**SECTION 00 90 01  
BIDDING AND CONTRACT REQUIREMENTS  
ADDENDUM NUMBER (3)**

**Re: ADDENDUM NUMBER (3) TO THE BIDDING DOCUMENTS FOR**

**Peoria Park District  
Golf Entertainment Facility Renovation an Addition  
Architect's Project Number: 22-051**

SHEET TITLE:  
**ENLARGED FLOOR PLANS - POWER & SYSTEMS**

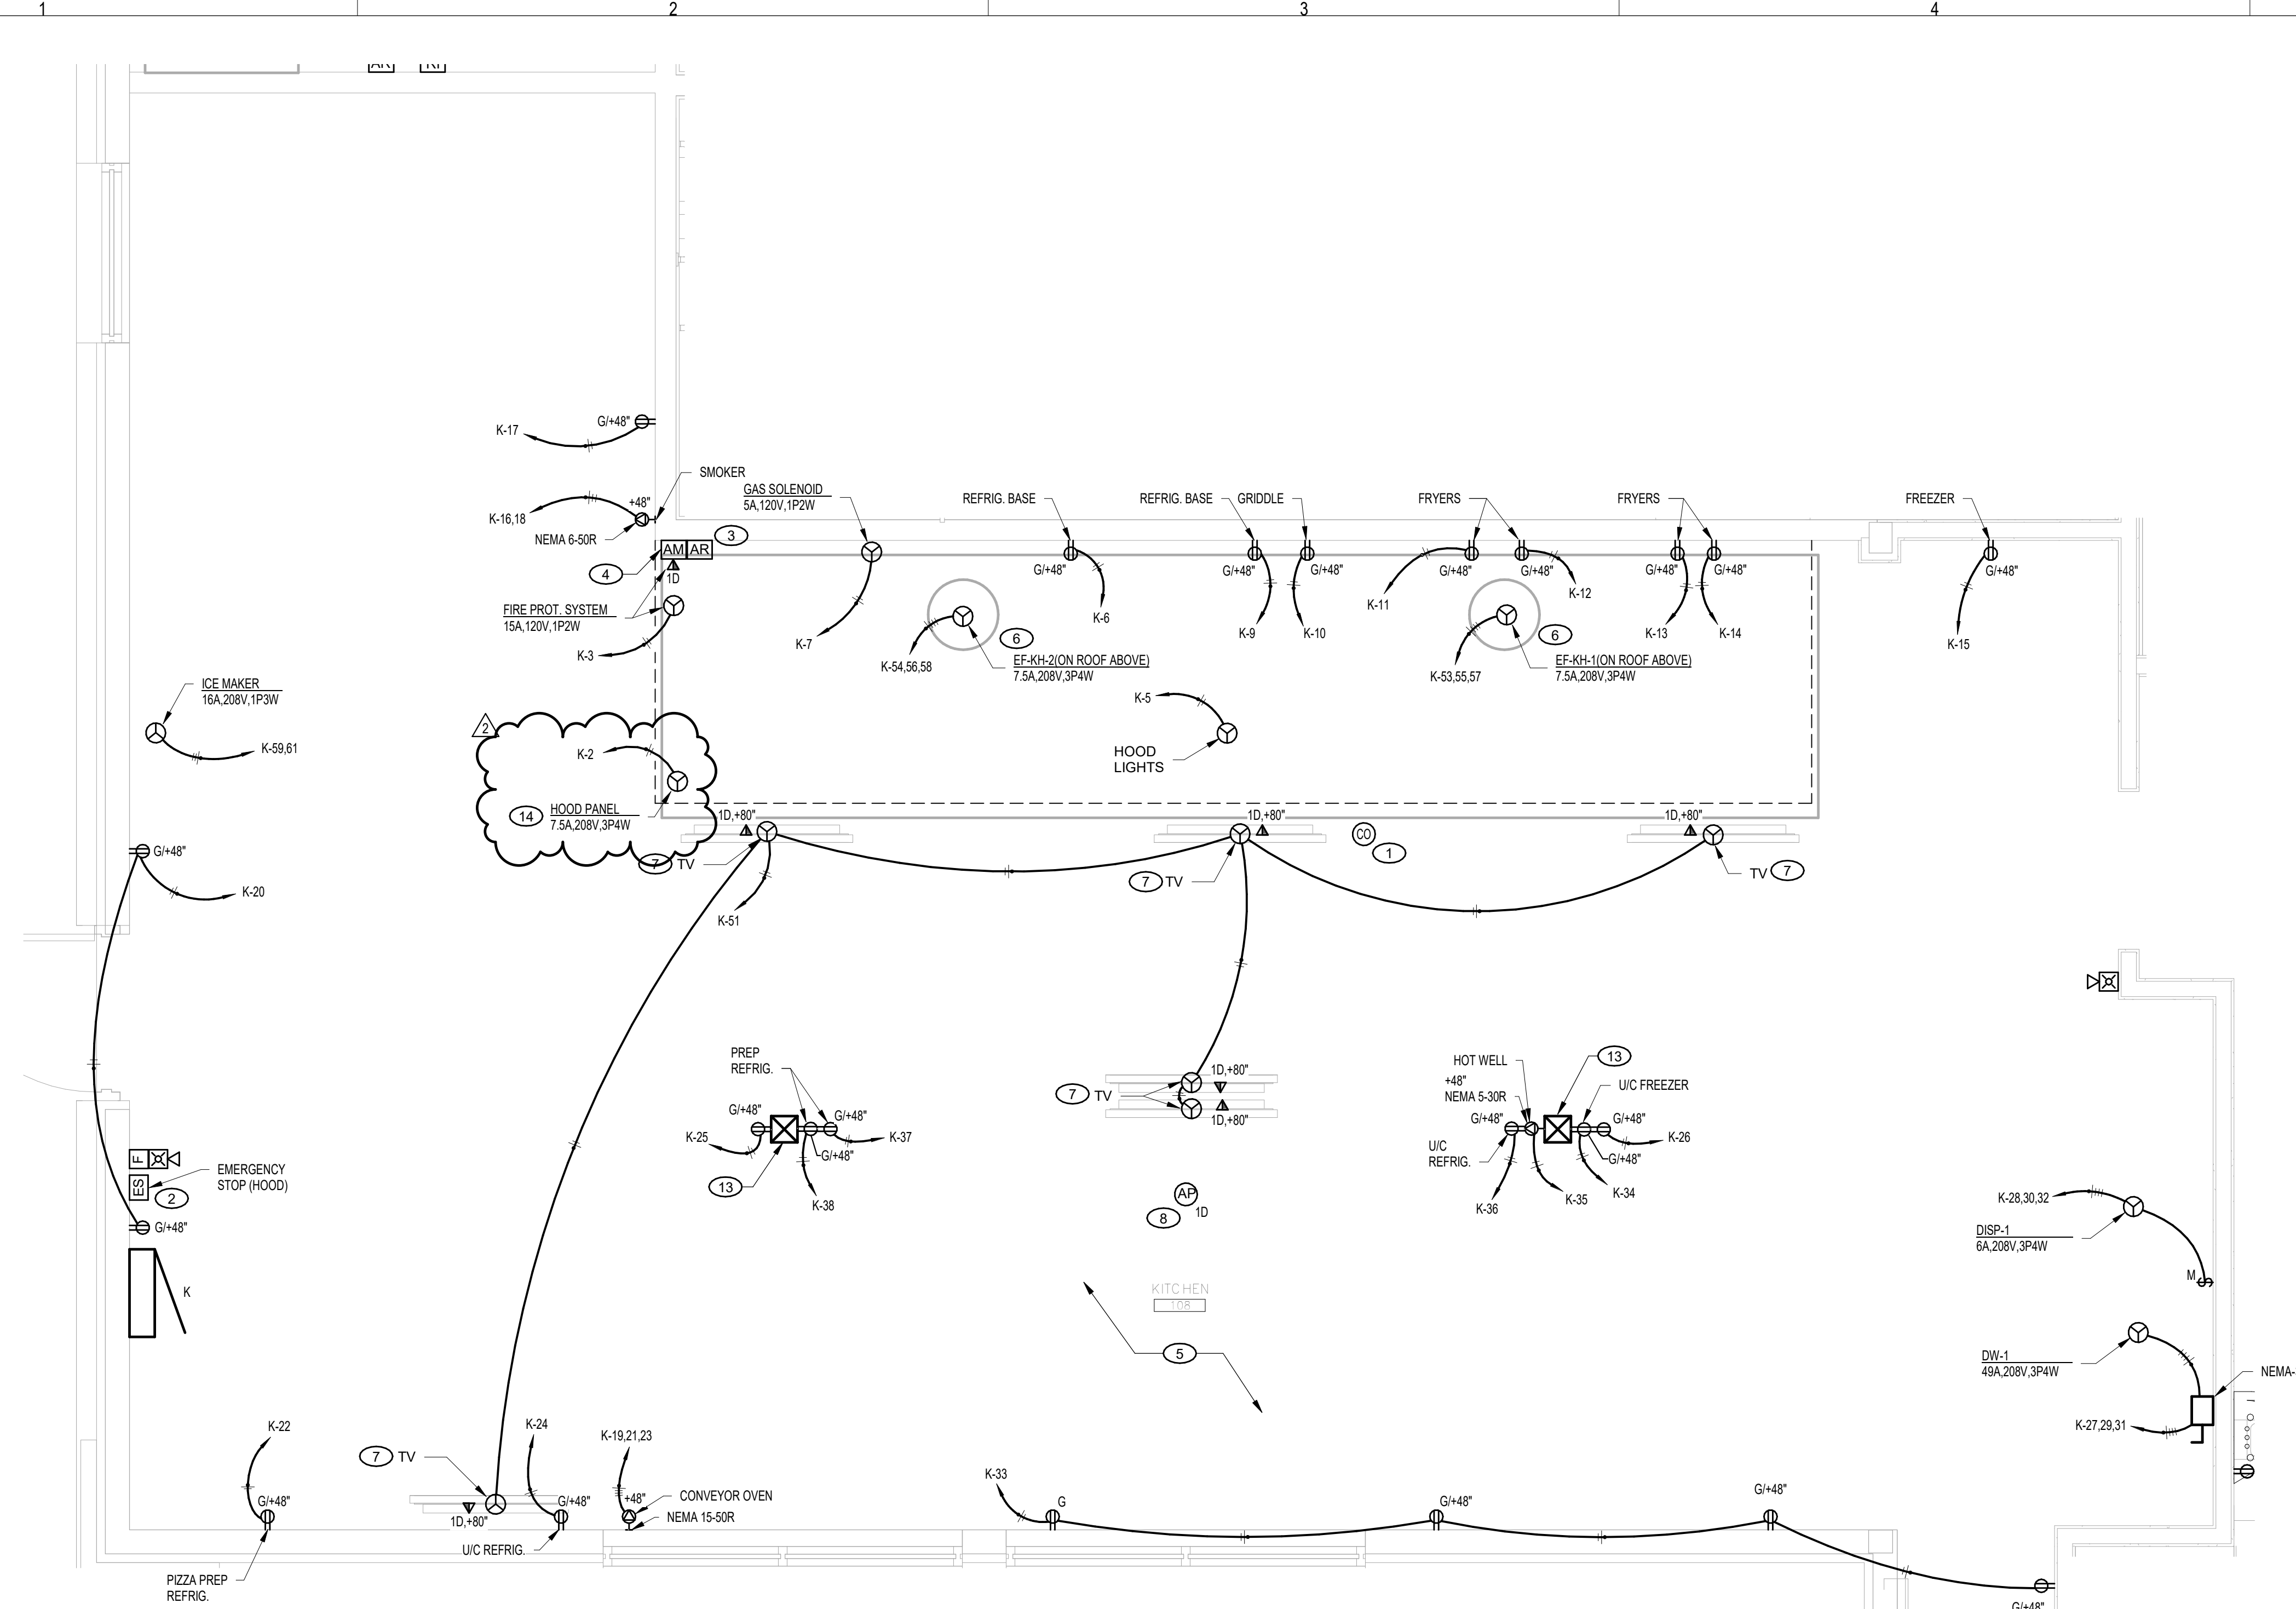
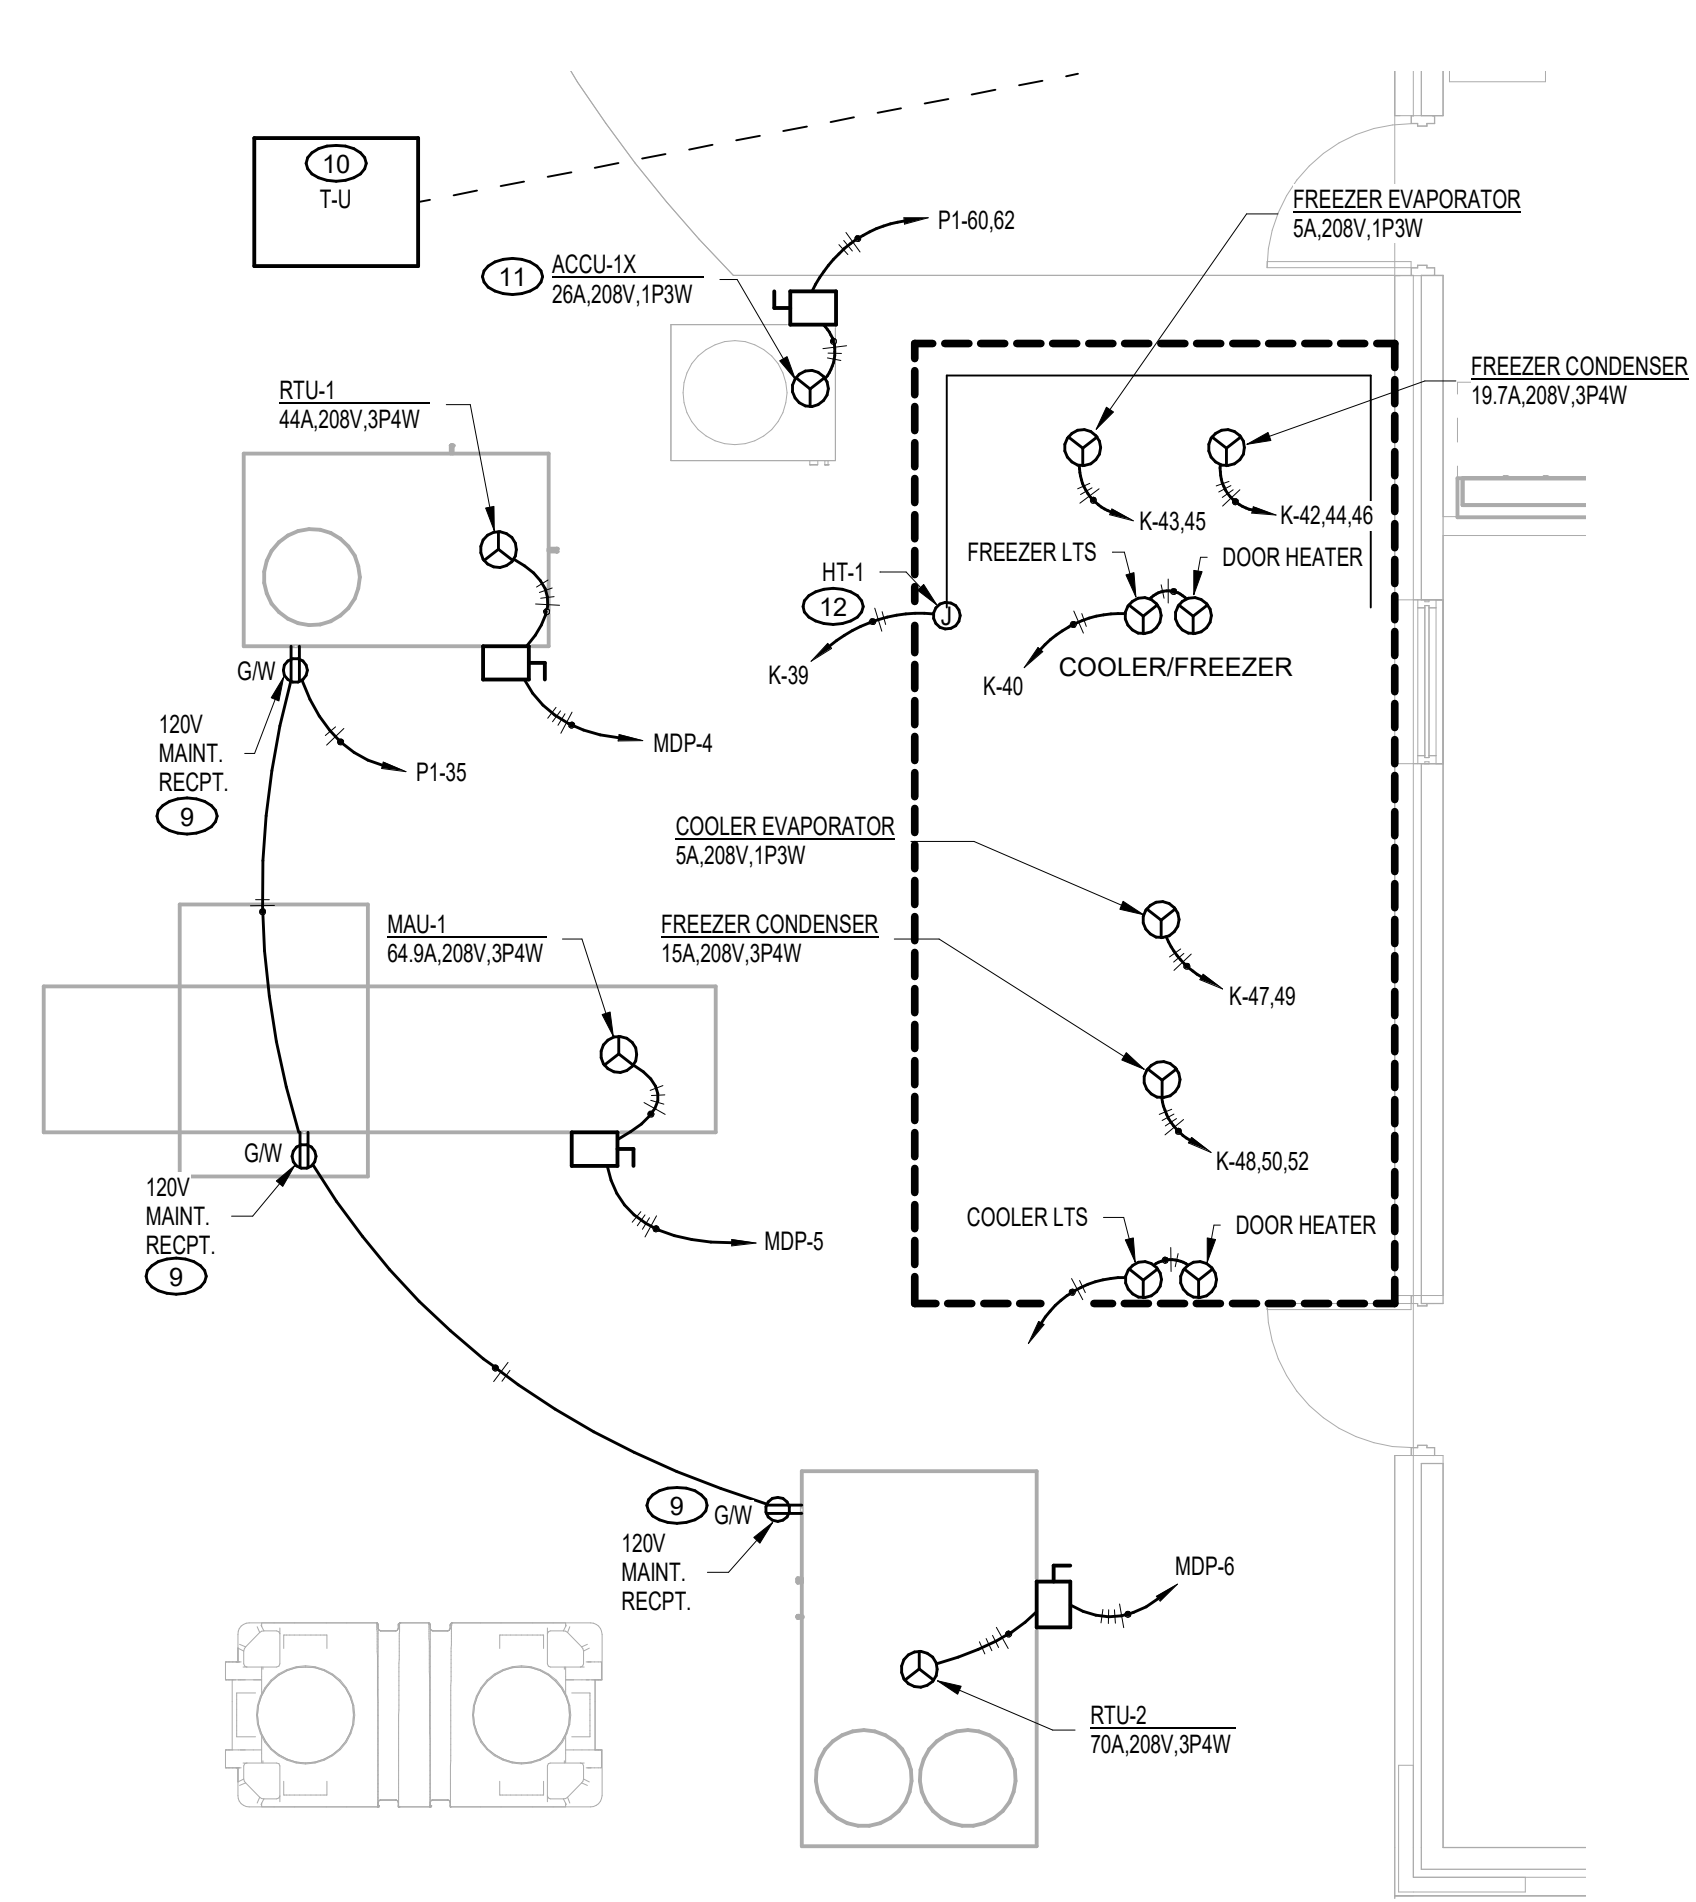
- d. Revise schedule for panel "P2" for LED tape light circuiting and panel size changes.
5. Drawing E3.0 – ENLARGED FLOOR PLAN – POWER & SYSTEMS
  - a. Revised connection for kitchen hood control panel from 3-phase to single phase.

- b. Added keyed note #14 for installation of hood shunt trip breaker.

- 14 FURNISH AND INSTALL SHUNT TRIP FOR HOOD SHUTDOWN UPON ACTIVATION OF FIRE SUPPRESSION SYSTEM. COORDINATE FINAL LOCATION WITH OWNERS REPRESENTATIVE AND KITCHEN INSTALLER PRIOR TO ROUGH-IN.

SHEET TITLE:  
**FIRE ALARM AND ACCESS CONTROL SCHEDULES AND DETAILS**

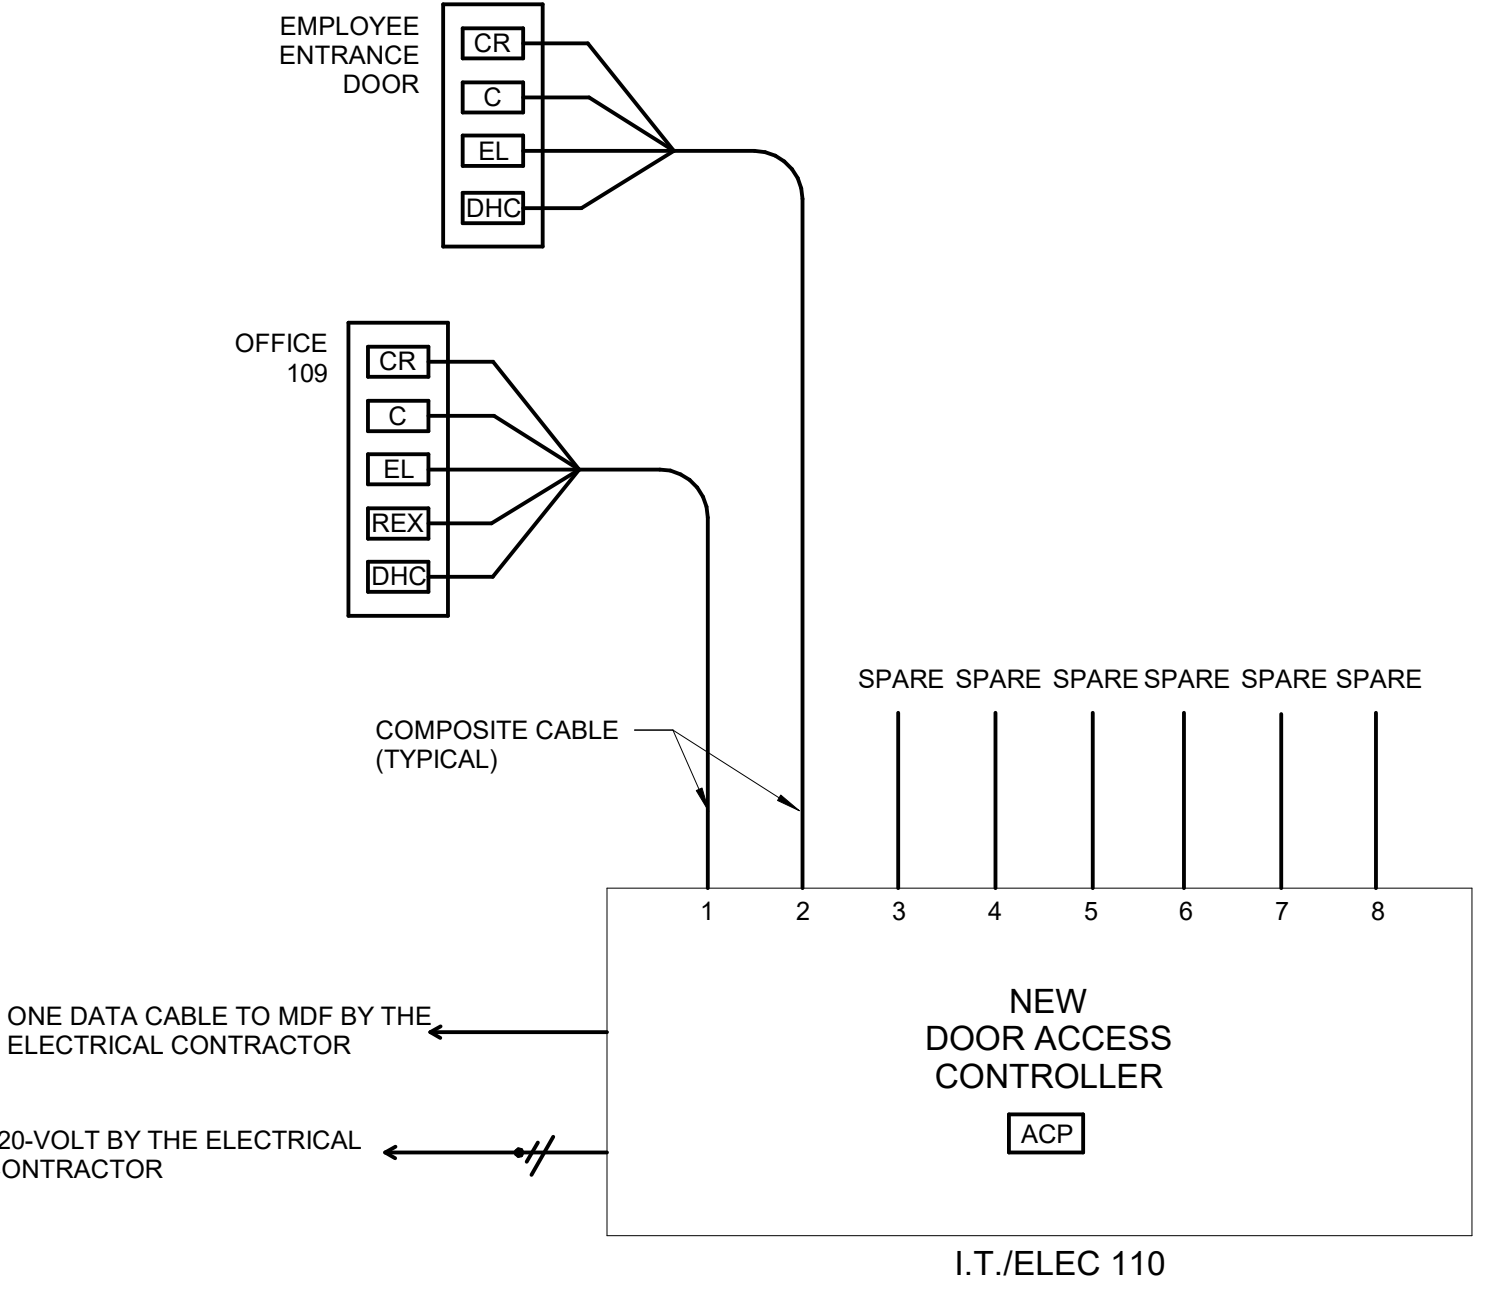
6. Drawing E4.0 – FIRE ALARM AND ACCESS CONTROL SCHEDULES AND DETAILS
  - a. Revised fire alarm schedule to clarify installation of non-addressable, conventional fire alarm system removing requirement of addressability of devices.
7. Drawing E4.2 – LIGHTING AND CONTROLS SCHEDULE AND DETAILS
  - a. Added fixture type 'P' to schedule for installation of 6" pendant cylinder fixtures.
  - b. Added box note to add approved manufacturers for lighting and controls.
8. Drawing E5.0 – ELECTRICAL GENERAL NOTES & DETAILS
  - a. Revise material schedule to correct transformer sizing from 100kVA to corrected 75kVA.

- FIRE ALARM SYSTEM GENERAL NOTES:**
- SEE PLANS FOR EQUIPMENT LOCATIONS AND DEVICE QUANTITIES.
  - NEW FIRE ALARM SYSTEM SHALL BE NON-ADDRESSABLE, CONVENTIONAL FIRE ALARM SYSTEM.
